**Comments
on
Valero's Appeal
of Planning Commission's Denial
of Valero Crude-by-Rail Project**

Benicia, California

April 4, 2016

Prepared by
Phyllis Fox, Ph.D., PE
Consulting Engineer
745 White Pine Ave.
Rockledge, FL 32955

Figure 7b:
Risk Profiles for Unloading Facility Crude Oil Spills and Fires¹¹⁴

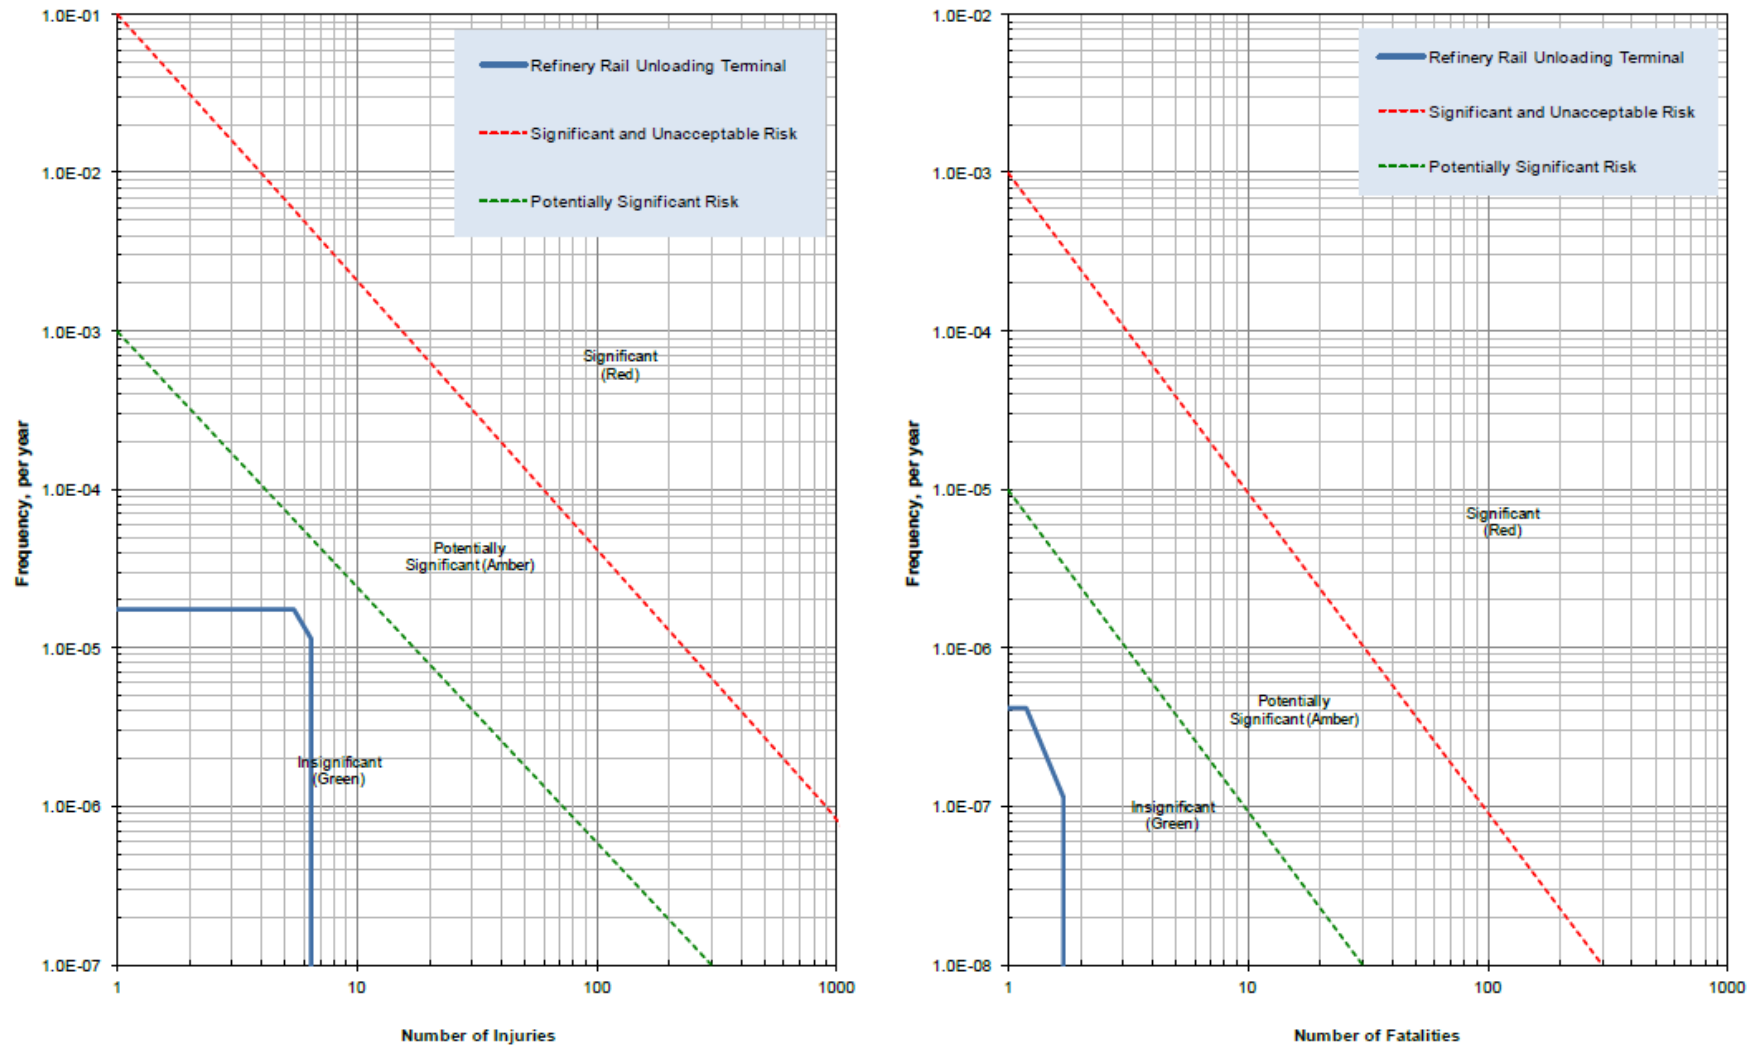
The EIR contains no support for the transition from worst-case thermal radiation hazards shown on Figure 4.7-8 (Figure 7a) to the risk profiles shown in Figure 4.7-9 (Figure 7b). The risk profiles for the unloading terminal magically appear (while those for mainline accidents are documented in Appendix F, Attachment 1). The transition requires: (1) an accident or failure frequency analysis to determine the probability of occurrence of each type of accident included in the consequence analysis at similar rail unloading terminals; (2) the annual chance of N or more injuries or fatalities; (3) population density information, *i.e.*, number of people per square mile; and (4) consequence area at each risk level (5 kW/m², 10 kW/m²) to estimate the exposed population affected by injury or death. The EIR does not include this information for the unloading terminal. Rather, the supporting appendix,¹¹⁵ Risk Assessment Methodology, in the section where this information should be found asserts:

Thus, the Valero EIR does not include any support for the transition from worst-case thermal hazard zones for the unloading terminal, as summarized in RDEIR Table 4.7-8 and Figure 4.7-8 (Figure 7a), to the risk profiles in RDEIR Figure 4.7-9 (Figure 7b). The risk profiles were used to determine the significance of on-site terminal unloading accidents, based on Santa Barbara County public safety thresholds. This represents a complete failure to support the critical step from the consequence analysis to the risk profiles.

I attempted to reproduce the risk profiles in RDEIR Figure 4.7-9 (Figure 7b) using information from the EIR, as supplemented by PRAs. My analysis indicates that these profiles cannot be reproduced without access to proprietary models and the input data that generated them. Further, my analysis indicates they significantly underestimate consequences (number of injuries and deaths) of the modeled accidents. The EIR estimated significance for the number of injuries and fatalities.

The risk profiles for injuries in RDEIR Figure 4.7-9 indicates that 5.3 to 6.4 injuries¹³⁰ would result from the worst-case on-site accident, which RDEIR Table 4.7-8 reports would extend out from the accident site by 1,585 feet at a wind speed of 20 meters per second (m/s). The RDEIR does not disclose how this injury estimate was derived. My calculations indicate it is a substantial underestimate.

Figure 9: Distribution of Hazards and Population Densities¹⁴⁴

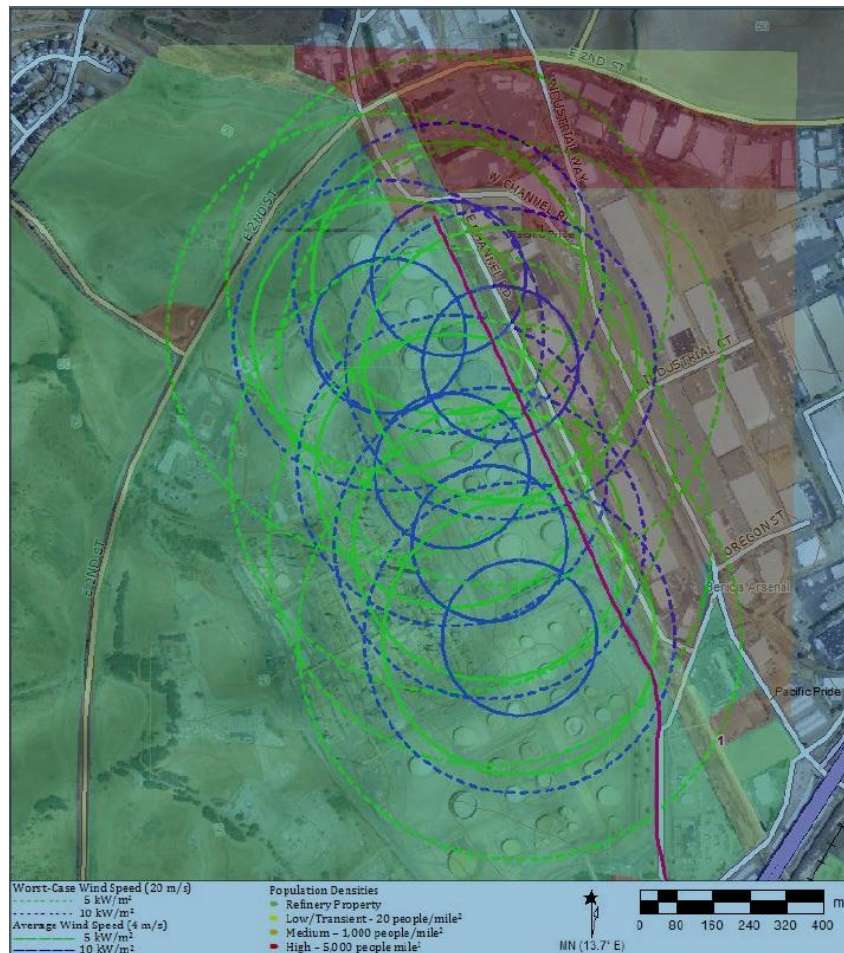
This figure shows that if the site of the accident were about 700 feet to the north, about one third of the 5 kW/m² contour would fall in the high population density area with 5,000 people per square mile. This would increase the number of injuries to more than 124.¹⁴⁵ Thus, the risk profile for injuries in RDEIR Figure 4.7-9 should show at least 124 injuries, not 5.3 to 6.4 injuries.

Figure 10:
Modified Risk Profiles for Unloading Facility
Crude Oil Spills and Fires, Injuries¹⁴⁷

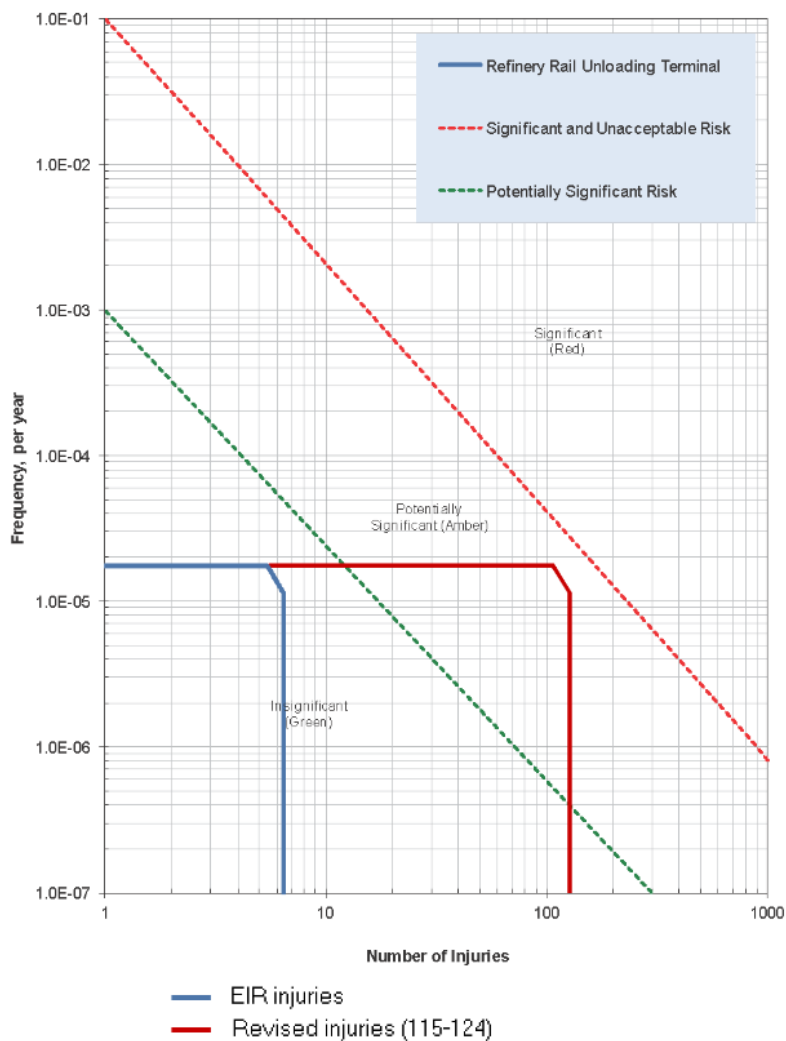
One hundred and twentyfour injuries extends the risk profile in Figure 7b into the potentially significant area,¹⁴⁶ as shown in Figure 10, assuming the accident frequencies presented by the EIR are correct. The number of injuries would be higher than the 124 estimated here, as the thermal radiation is higher throughout most of the

two zones I used in my calculations than the assumed 5 kW/m² and 10 kW/m² significant levels. This is a significant impact that was not disclosed in the EIR.

**Figure 11: Modified Risk Profiles for Unloading Facility
Crude Oil Spills and Fires, Fatalities¹⁵⁴**

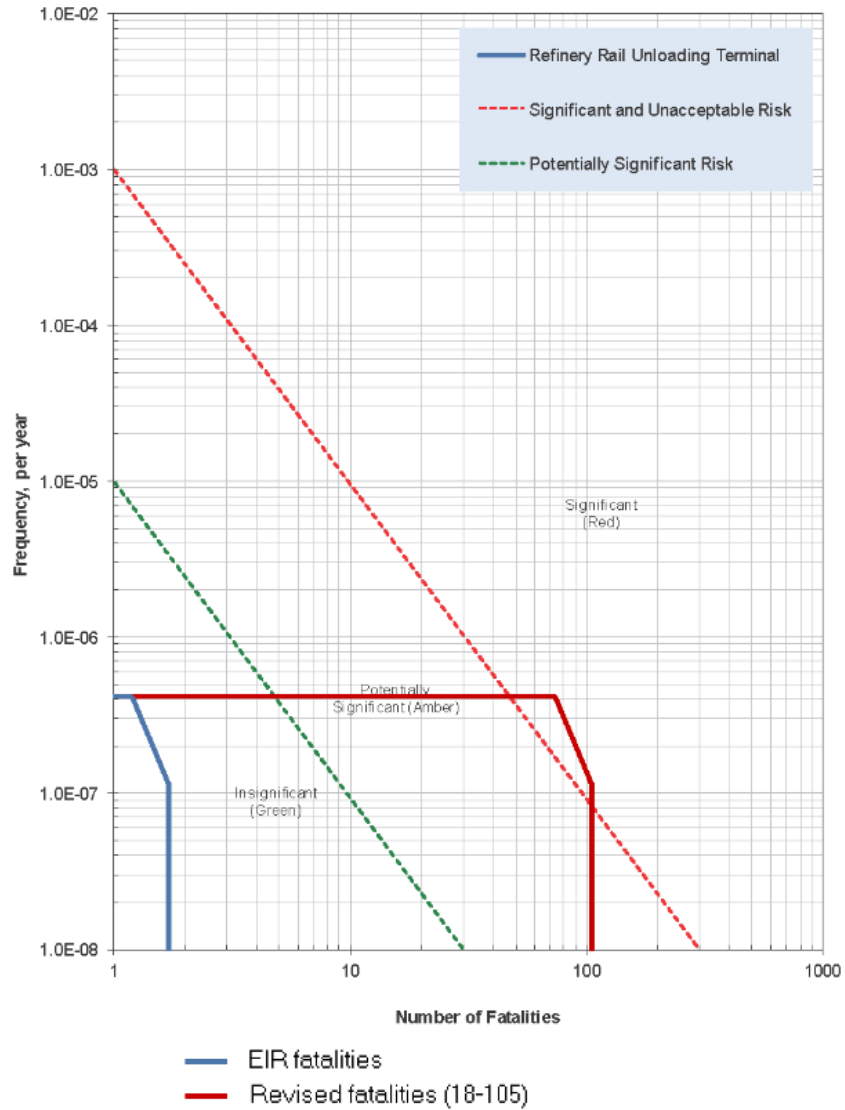
Therefore, the risk profile for fatalities should show at least 18 fatalities. It does not, but rather shows 1.5 to 1.8 fatalities. With 18 fatalities, the risk profile would extend into the potentially significant area,¹⁵³ while 105 fatalities would place it in the potentially significant zone. Figure 11. But the number of fatalities would be even higher than the lower bounds of 18 to 105 fatalities estimated here, as higher thermal radiation is present closer to the accident site, placing the number of fatalities in the significant zone.

Figure 17¹⁷⁹

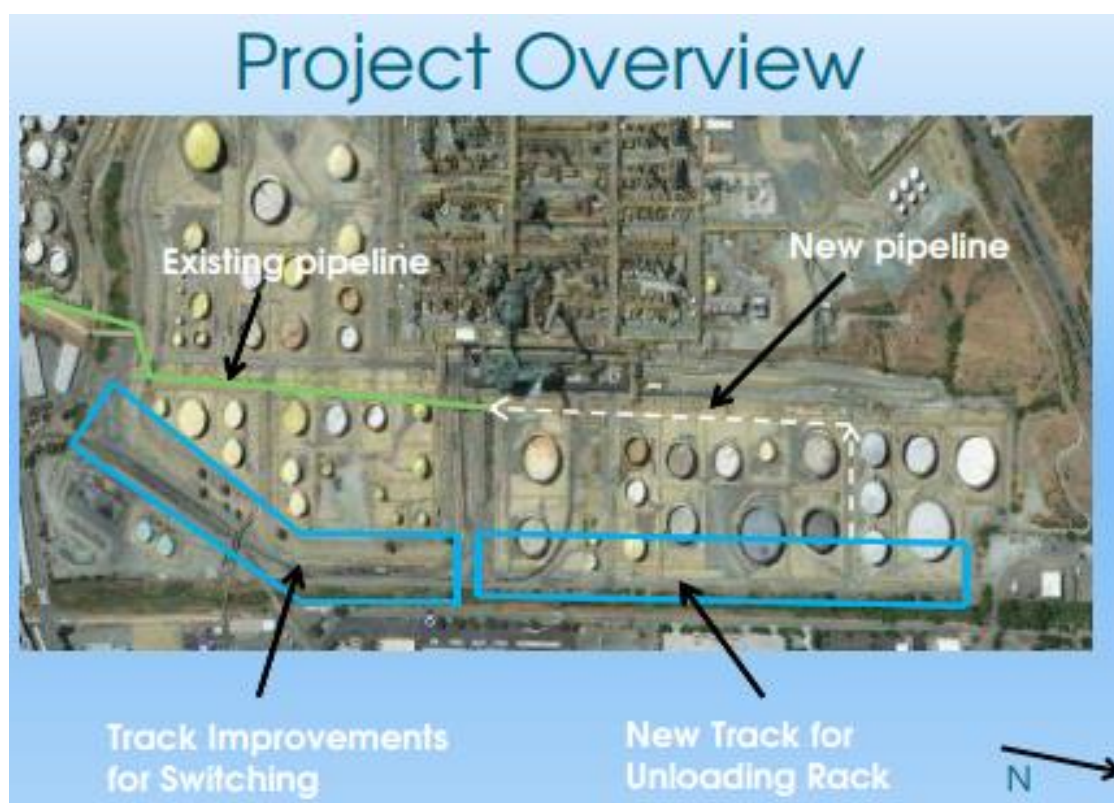
The EIR did not evaluate a pipeline accident, presumably because it assumed the Supervisory Control and Data Acquisition (SCADA) system would detect a failure within 1 minute, limiting the pipeline and pumping loss. The worst-case spill from emptying the pipeline under this theory would be only about 73,000 gallons, which would occur where the pipeline connects with the unloading pumps and would drain into the area around the pipeline and unloading rack.¹⁸⁰

Further, the causes, probability, and consequences of a pipeline accident depend on where the pipeline is located. The record is not clear on pipeline location. The RDEIR states that the pipeline will be located “between the two rail spurs at slightly below ground level.”¹⁸¹ Elsewhere, the RDEIR states an “above ground pipeline would be routed along an existing internal road on the Valero property between the unloading facility and the Refinery”¹⁸² and elsewhere, it is described as simply “aboveground.”¹⁸³ The March 15, 2016 City Council slides (Figure 17) show the pipeline inside of the tank farm, rather than at the Project site between rail spurs. The probability of an accident depends on location, which is currently uncertain.

**Figure 20:
Fishbone Diagram of Accident Prevention²⁰²**

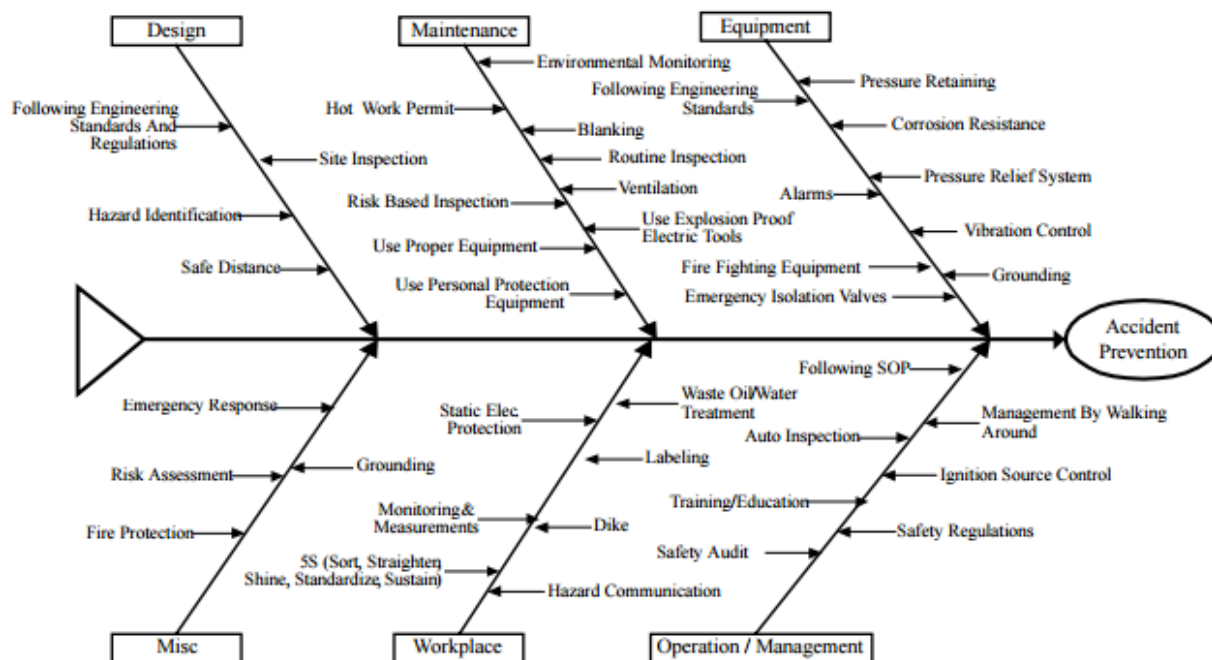
The EIR fails as an informational document as it did not include any analysis of tank accidents. The EIR must be revised to include tank accidents due to a switch in the type of crudes stored in these tanks and identify feasible mitigation. Feasible mitigation is identified in Figure 20.

Figure 28:
Ground Shaking Amplification at Project Site²⁴²

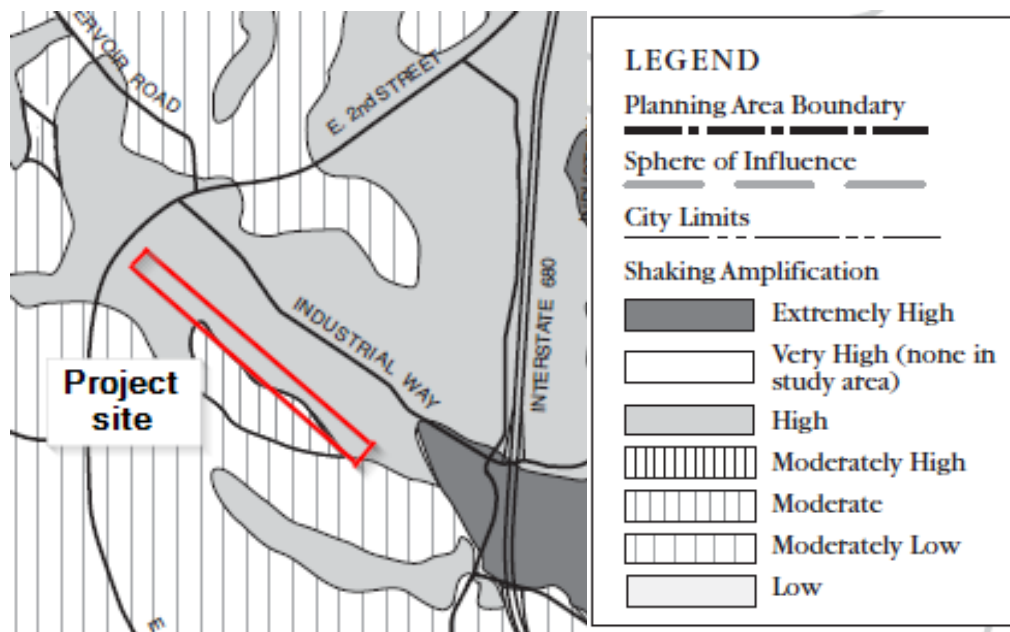
the EIR admits is likely to occur over the Project lifetime.²³⁸ As a comparison, the maximum ground accelerations recorded in San Francisco and Oakland during the 1989 Loma Prieta earthquake were about 0.2 g.²³⁹ Ground shaking could tip railcars off tracks and disconnect them from the unloading rack, events not addressed by structural design codes.²⁴⁰ Further, the Benicia General Plan, Figure 28, shows that the Project site is in an area with “high” shaking amplification, which is distinct from “lateral spreading and settlement hazards”.²⁴¹

The impact of earthquake-induced ground shaking was raised in Comment B8-108, based on the Benicia General Plan.²⁴³ The EIR’s response to this comment only states geotechnical investigations “identified potential for lateral

Figure 33:
2015 Flood Insurance Map Panel 634, Showing Project Site²⁹⁴

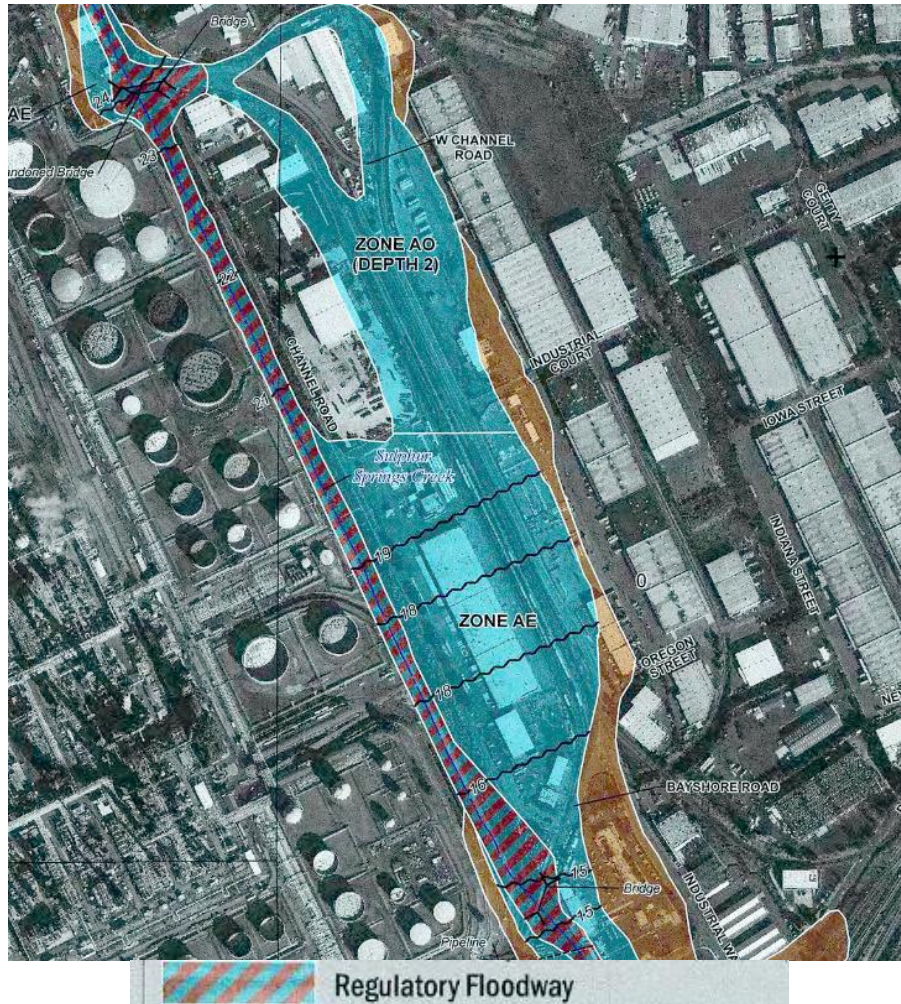
Further, FEMA is currently in the process of completing the San Francisco Bay Area Coastal Study, a comprehensive coastal hazard analysis of San Francisco Bay coastal communities. Benicia is included in this study. The preliminary Flood Insurance Rating Map (FIRM) for the Project site continues to confirm that the entire project site is characterized as a “special flood hazard area” and is further specifically classified as a “regulatory floodway.”²⁹² See Figure 33. The FEMA website indicates a “regulatory floodway” means:

The EIR does not disclose that the Project site is located in a “regulatory floodway” and does not explain how the Project site will comply with this definition. The EIR further fails to explain how the Project will be designed to assure no increase in water surface elevation, given the potential presence of up to 150 railcars at the site, plus the unloading facilities and new pipeline which will fill volume available in the baseline for floodwaters.

The EIR does not discuss design criteria to comply with FEMA regulations and the City of Benicia Floodplain Management Policy.²⁹⁵ Further, the proposed infrastructure is inconsistent with the site's classification as a "regulatory floodway." Development is not allowed in a floodway if it would increase the water surface elevation. As demonstrated in Comment V.C, the Project would increase flood water surface elevation.
